February 6, 1984

Docket No. 50-423  
B11026

Millstone Nuclear Power Station, Unit No. 3  
Probabilistic Safety Study (PSS)

47.500

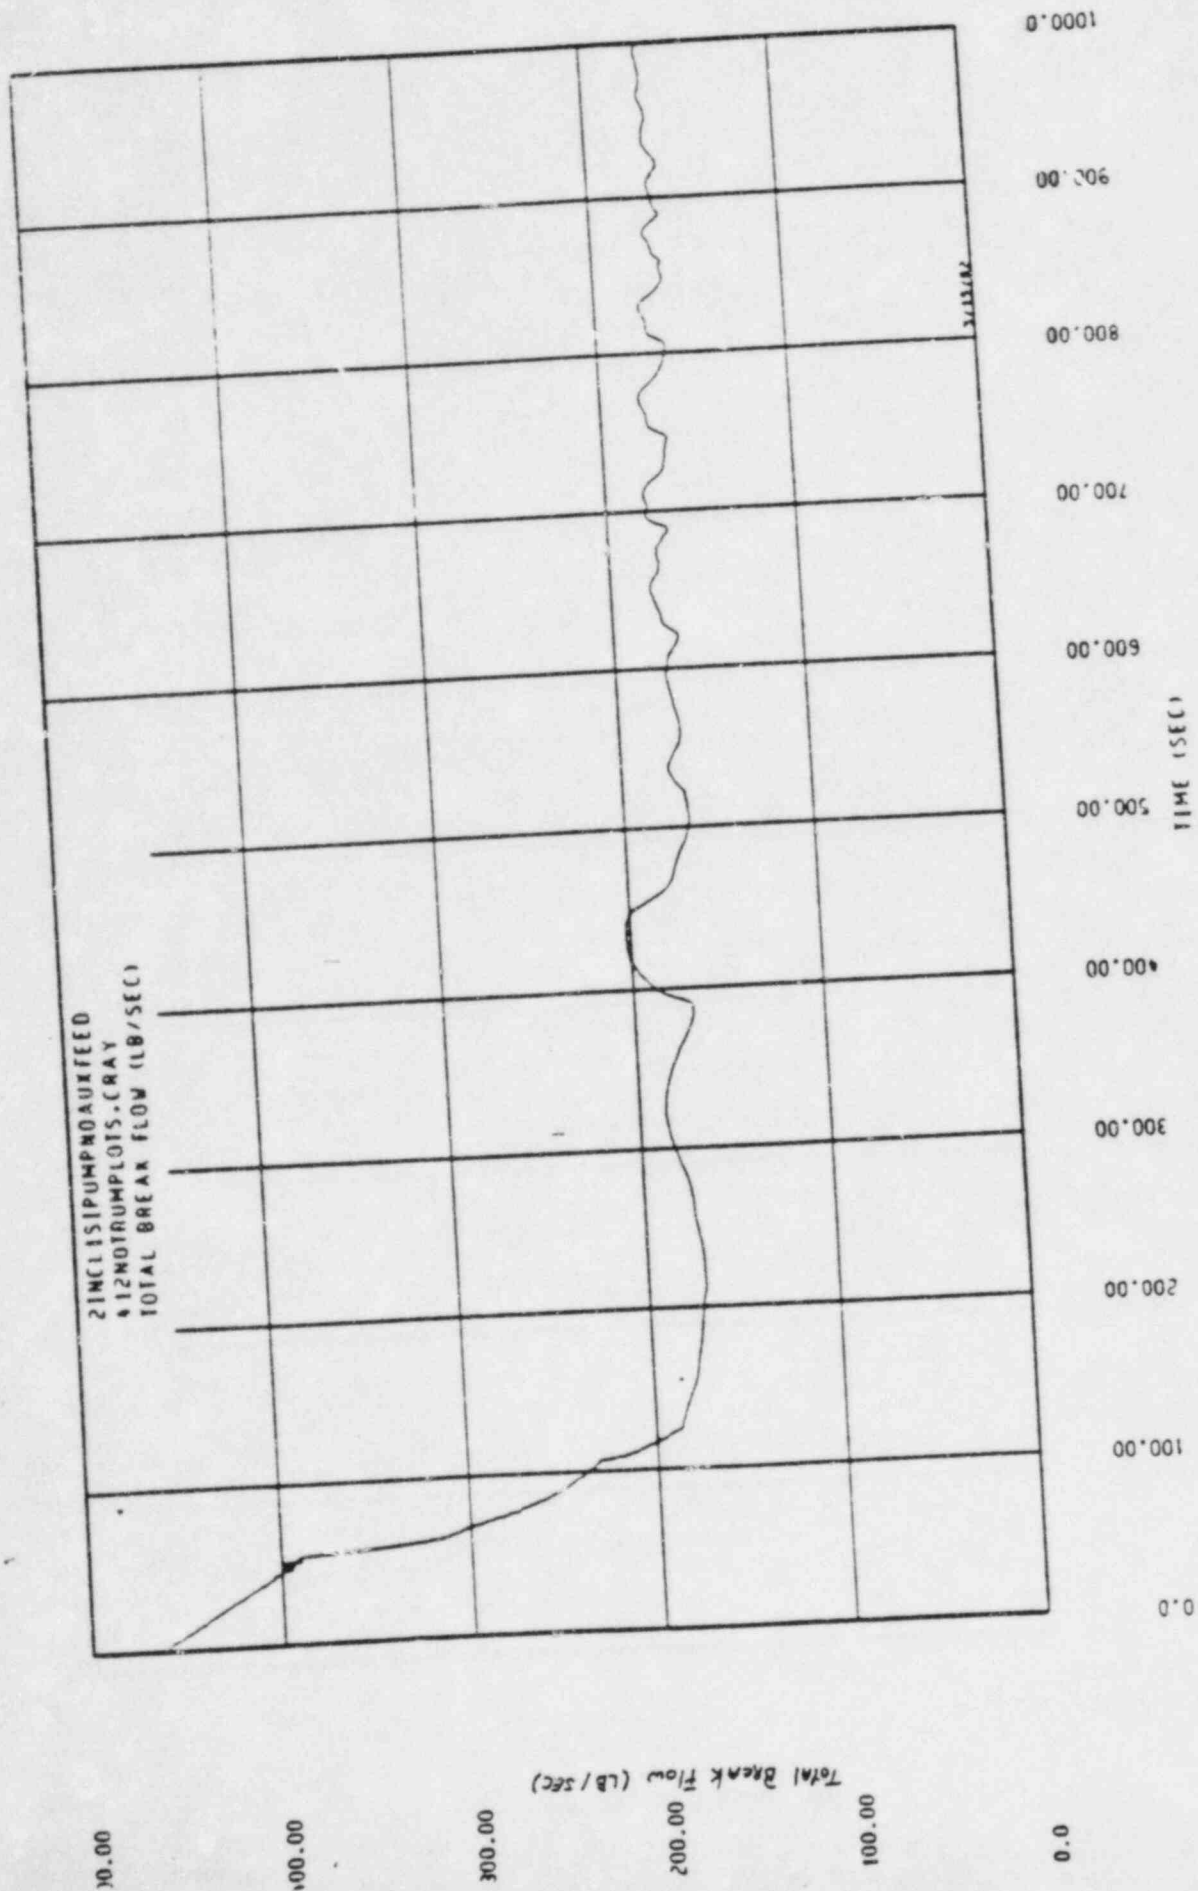
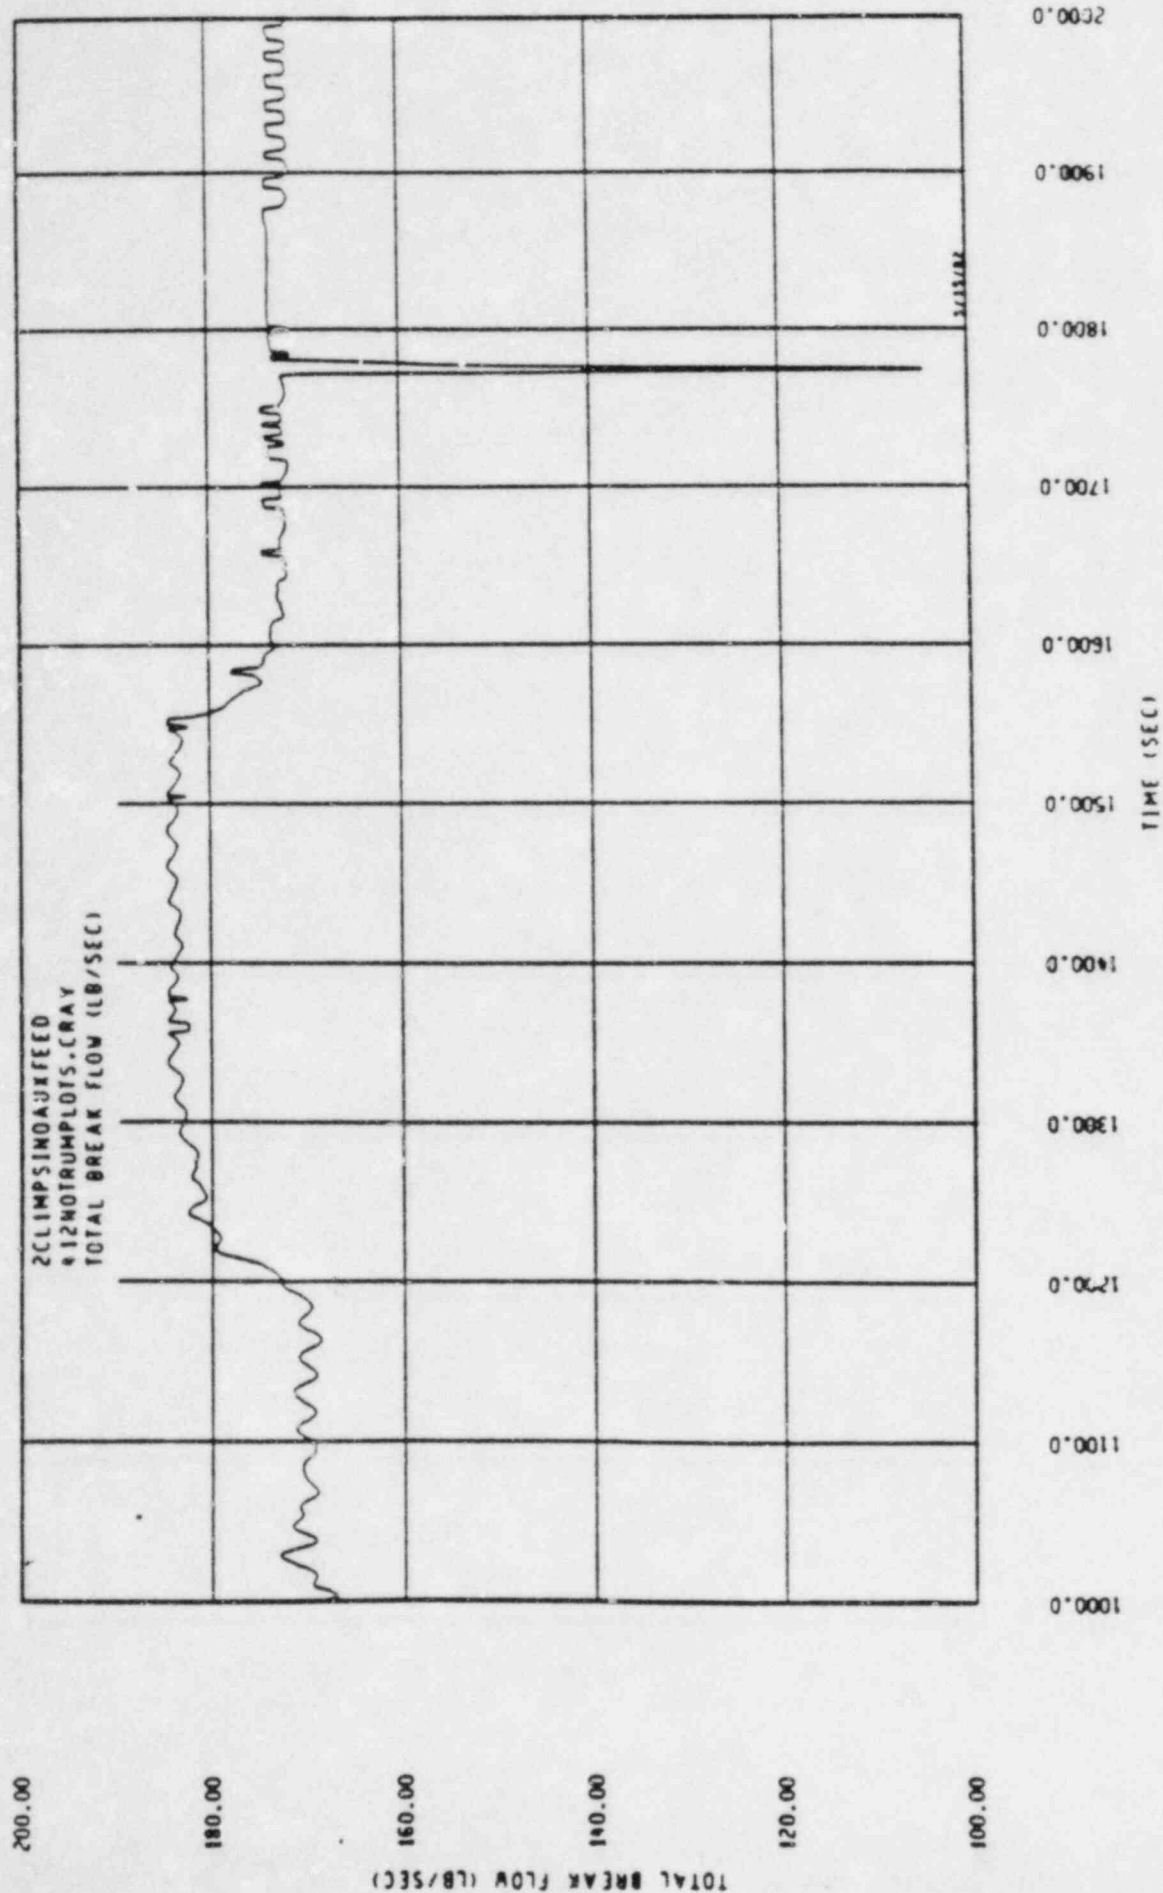
Question 720.3: Provide a summary of Westinghouse Calc Note CN-PRA-83-022 which identifies computer codes used, key assumptions and transient plots used in the analysis.

Response: Westinghouse Calc Note CN-PRA-83-022 provides the necessary calculations to assess the reactor coolant system response to postulated small and medium break loss of coolant accidents for which only minimum safety injection capability is available. The results of these analyses were utilized along with other similar analyses to determine system success criteria for the Millstone Unit 3 PRA.<sup>(1)</sup> This calc note analyzed breaks of 2- and 6-inch diameters. For both breaks, the location was assumed to occur at the RCS cold leg which is the limiting break location for Westinghouse PWRs.<sup>(1)</sup>

The NOTRUMP<sup>(2)</sup> computer code was used to perform the necessary calculations. NOTRUMP is a generalized one-dimensional network code which is used to model operational and severe transients for Westinghouse PWRs. An input model was developed for Millstone Unit 3 and a steady state full power simulation was established and referenced. The two LOCA events analyzed were: Case A models a 2-inch diameter cold leg break from full power conditions and Case B models a 6-inch diameter cold leg break from full power conditions. In both of these cases, it was assumed that no feedwater (normal or auxiliary) was available. This assumption has minimal impact on system response. The minimum safety injection flow to the RCS for both cases was approximately 75% of the capacity of one Millstone Unit 3 high head safety injection pump. This flow rate was chosen to bound the success criteria for Millstone which uses a combination of high head safety injection and charging pumps to accomplish high pressure injection. One charging pump provides approximately 75% of the flow of one SI pump in the pressure range of 0-1200 psig.

Case A calculations were carried out to 2000 seconds of transient time. While this particular calculation was not carried out to a time when the system is in a long term stable condition, the calculation was taken out far enough to show that the trend of the transient would not result in core damage/melt.

These two analyses show that while the flow minimum safety injection flow cannot maintain the RCS inventory above the break location, the flow is sufficient to maintain the vessel mixture level core the core. These conclusions were consistent with conclusions reached for similar LOCA analyses.<sup>(1)</sup> A detailed description of small break LOCA phenomena can be found in WCAP 9600. The transient time plots for key plant parameters for both cases are provided herein.
